MEETING: REGULAR MEETING OF THE PLAN COMMISSION
DATE & TIME: Monday, May 13, 2024 at 6:30 PM
LOCATION: Germantown Village Hall Board Room
N112 W17001 Mequon Road

5/13/24 Plan Commission Meeting

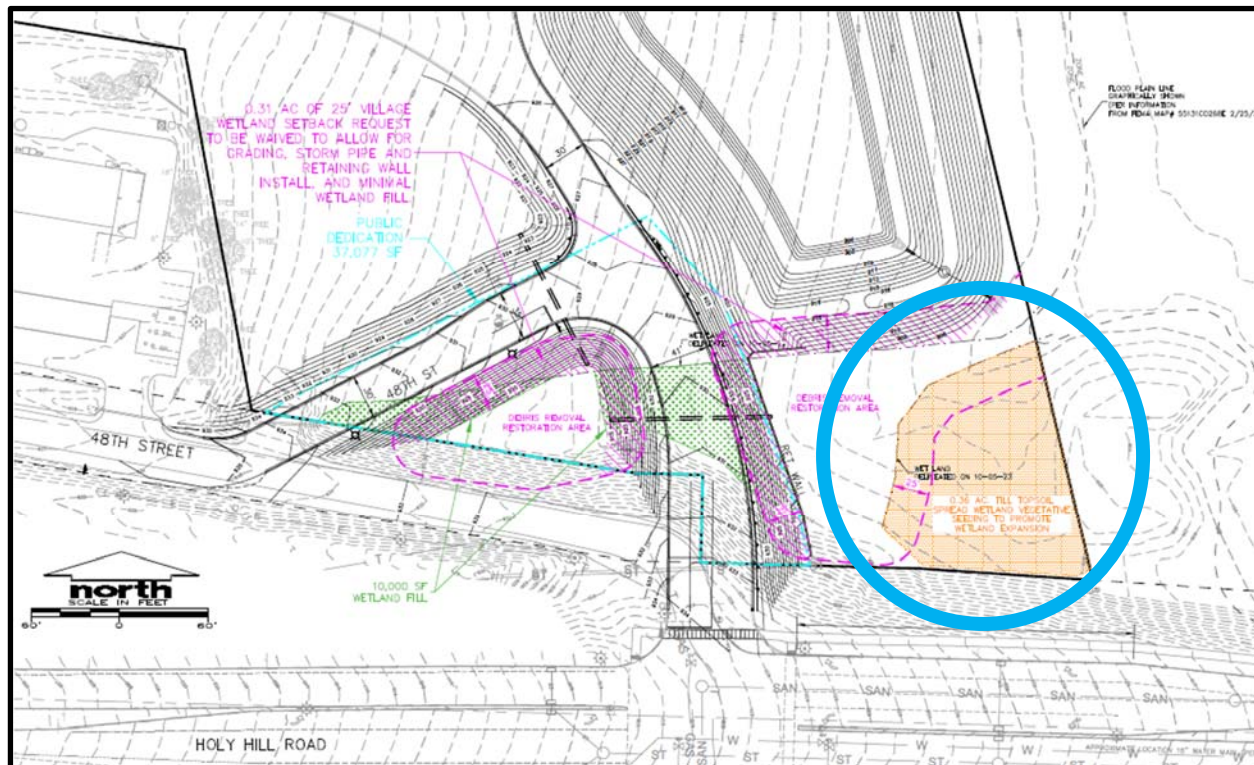
The proposed compensation area shown in the driveway/intersection design plan above (circled in BLUE) indicates .36 acres (15,680 sqft) vs. the proposed amount of compensation of .656 acres (28,580 sqft). The additional area of compensation proposed needs to be shown where and in what form on the site. The CUP compensation plan narrative needs to be revised to address this discrepancy to accurately show where, how much and what type the compensation plantings will be for the entire 28,580 sqft compensation area.

More detail is required on the type, amount, and location of plantings/seeding to be installed as compensation.

2. The Property Owner shall submit a revised compensation plan narrative and plan graphic that accurately indicates the type, amount, and location of the proposed compensation plantings and/or seeding for the entire 28,580 sqft compensation area. The revised narrative should also include more detail on the type and amount of plantings and seeding mix to be installed as compensation.
